SUBJECT: Suggestion #CELMN920007 - Review of Need for Out-Year
Levee Lifts -- Wave Runup

SUBJECT: Cost Estimates for Model Studies of Lake Pontchartrain

SUBJECT: Lake Pontchartrain La. and Vicinity Hurricane Protection Project Wave Design Criteria to be Used in Design of Proposed Breakwaters for Pumping Stations 2 and 3 Jefferson Parish, La.

SUGGESTION FOR DESIGN REVIEW OF OUT-YEAR LEVEE LIFTS
FOR NOD HURRICANE PROTECTION PROJECTS

JEFFERSON PARISH LEVEE DESIGN WAVES, RUNUP, HEIGHT VS WINDSPEED

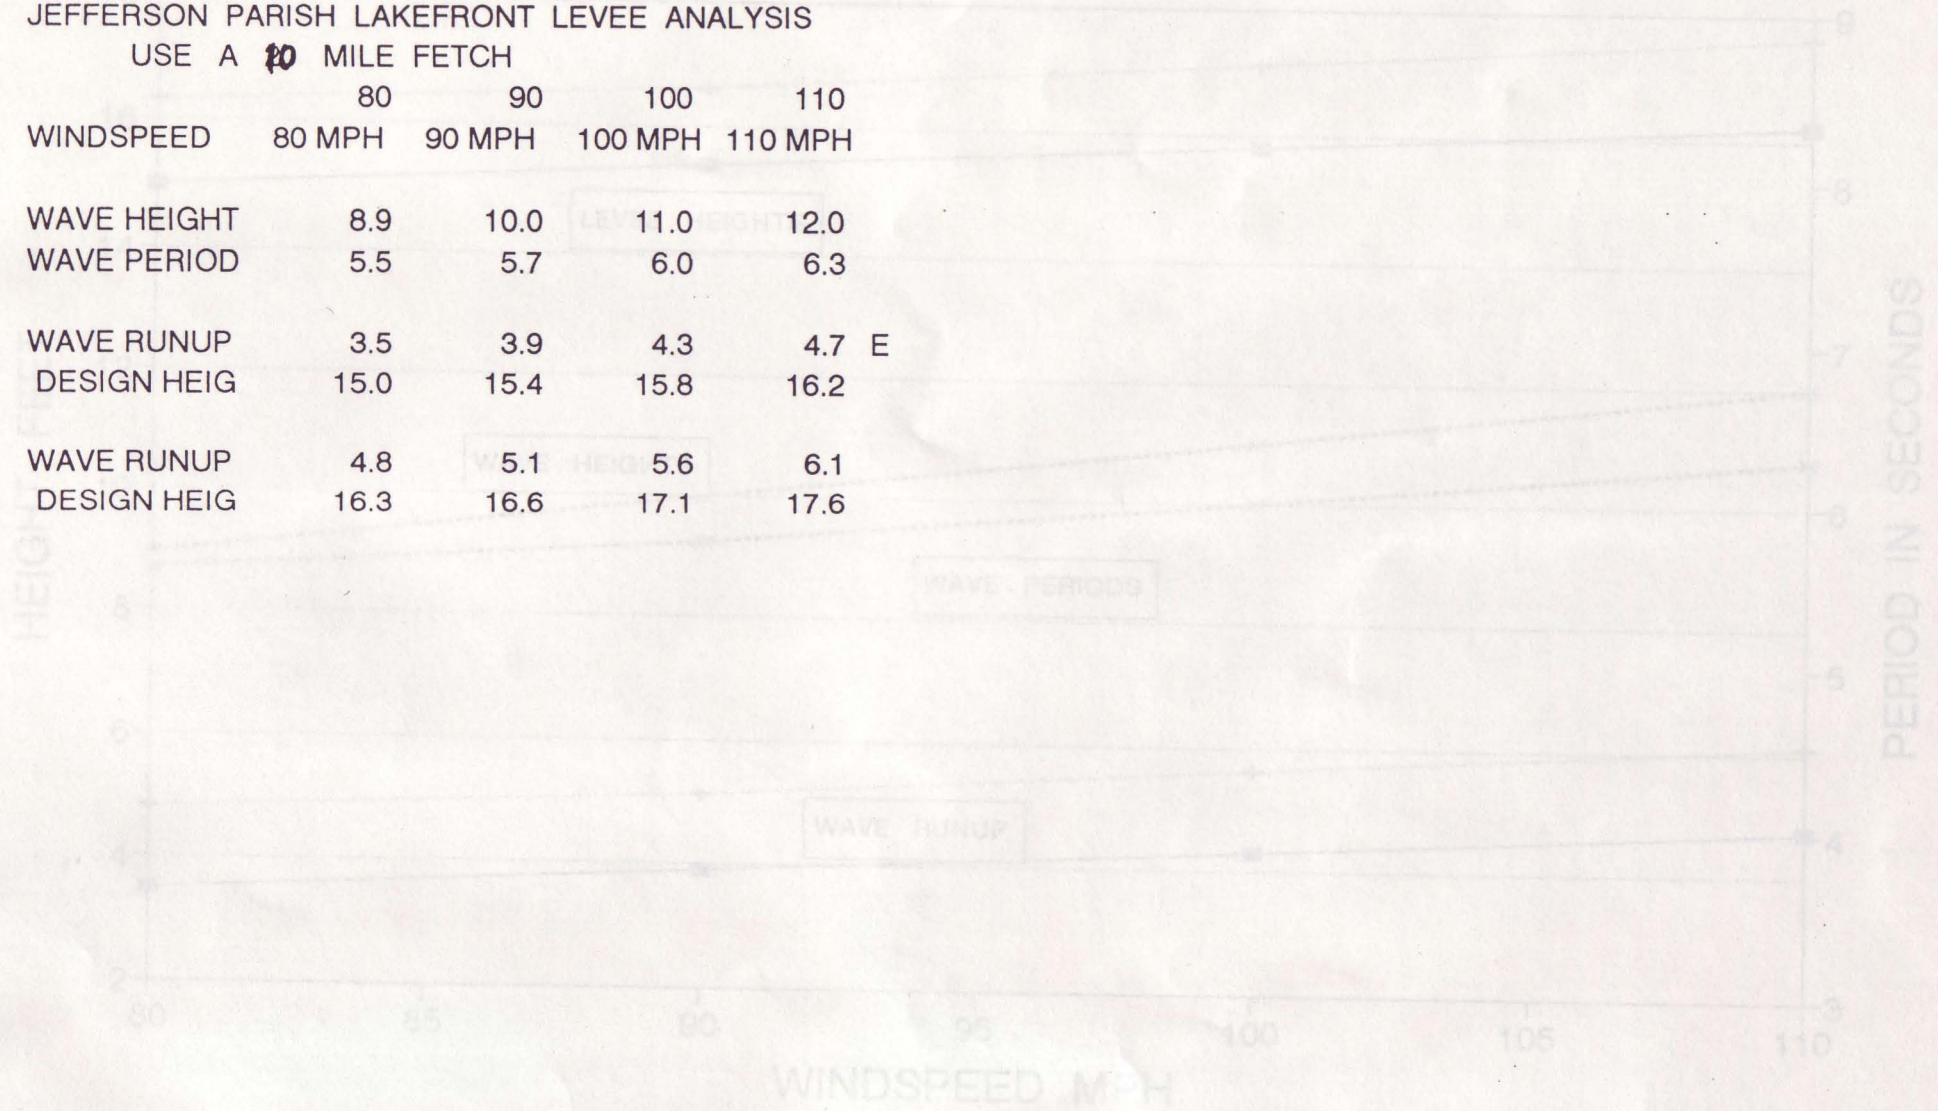
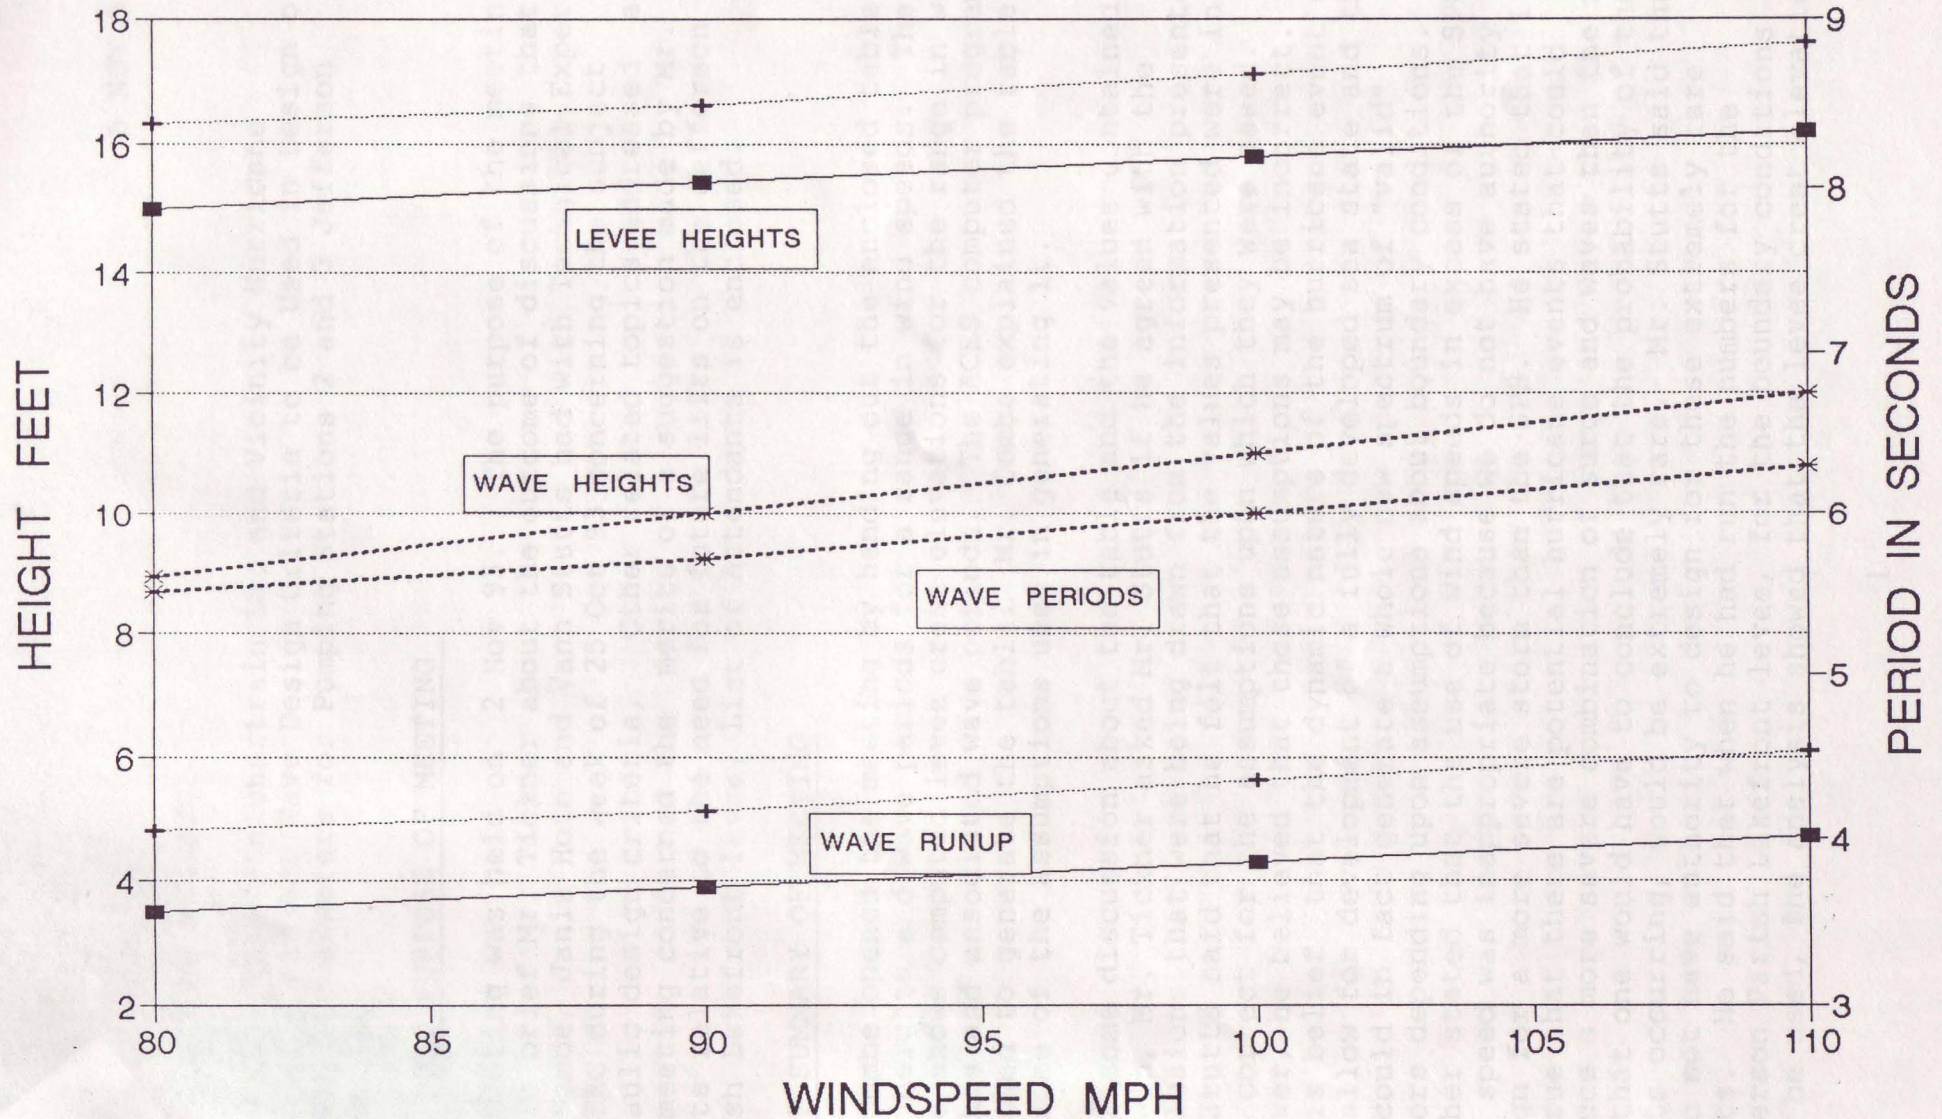
Mr. Combe opened the meeting by handing out the enclosed table of wave heights and wave periods for a range in wind speeds. The table shows computed levee crest elevations for the range in wave heights and associated wave periods. The ACES computer program was used to generate the table. Mr. Combe explained the table and some of the assumptions used in generating it.

After some discussion about the table and the values contained therein, Mr. Tickner asked Mr. Stutts if he agreed with the conclusions that were being drawn from the information presented. Mr. Stutts said that he felt that the values presented were in fact correct for the assumptions upon which they were based. However, he believed that those assumptions may be incorrect. It is his belief that the dynamic nature of the hurricane event did not allow for development of a fully developed sea state and that one could in fact generate a whole new spectrum of "valid" answers depending upon assumptions about boundary conditions. He further stated that the use of wind speeds in excess of the SPH wind speed was inappropriate because we do not have authority to design for a more severe storm than the SPH. He stated that it is true that there are potential hurricane events that could produce a more severe combination of surge and waves than the SPH but that one would have to conclude that the probability of these events occurring, would be extremely rare. Mr. Stutts said that we do not have authority to design for these extremely rare events. He said that when he had run the numbers for the Jefferson Parish Lakefront levee, for the boundary conditions that he used, the analysis showed that the levee crest elevation

could be as low as 14.0 feet n.g.v.d. but that conservatively 14.5 would probably be more adequate.

USE A ~~10~~ MILE FETCH
